Product Change Notification

Change Notification #: 113648 - 00
Change Title: Intel® Server System R2208GL4GS
PCN 113648-00, Product Design
Update Resistors and Capacitor of PCIe Riser
Spare A2UL8RISER, and
BIOS/ME/BMC/FRUSDR Firmware
Date of Publication: February 19, 2015

Figure-1: Component Locations for the 2U Riser Spare A2UL8RISER

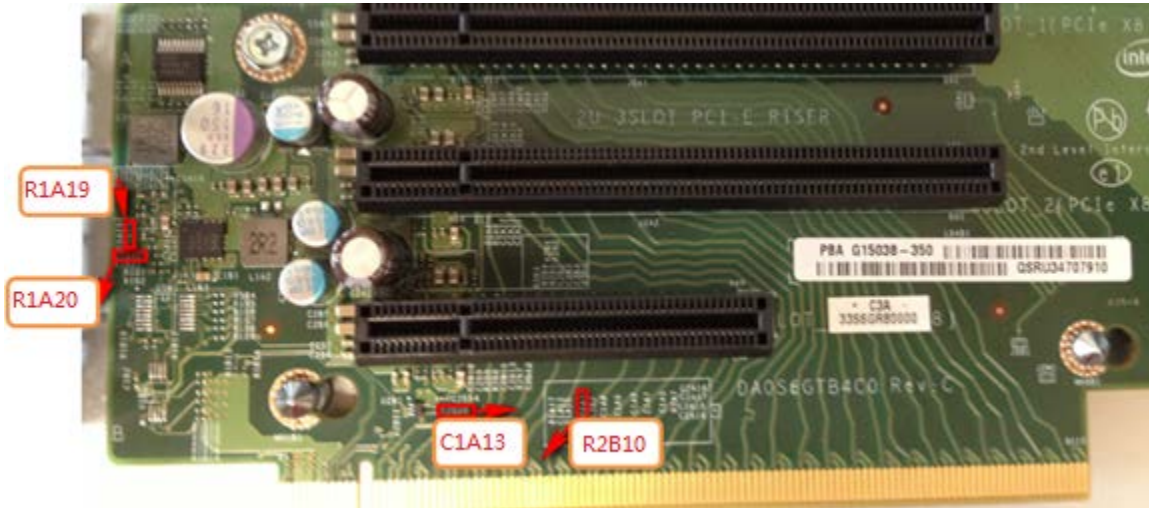
2. Update the following resistors and capacitor (see Table-1 and Figure-1) on the 2U PCIe Riser Spare A2UL8RISER to make an improvement to support a higher 3.3 Voltage Regulator startup over current. Before this change, the Voltage Regulator on the riser card may not be able to turn on when the total current drawn is more than 5A current. After this change, the Voltage Regulator on the riser card can support more than 10A current.

| Component | Location | Pre-change | Post-change |
|-----------|----------|------------|-------------|
| Resistor | R2B10 | 10.00 kOhm | 3.65 kOhm |
| Resistor | R1A20 | 0 Ohm | 30 Ohm |
| Resistor | R1A19 | 40.20 kOhm | 20.00 kOhm |
| Capacitor | C1A13 | 10.00 pF | 120.00 pF |
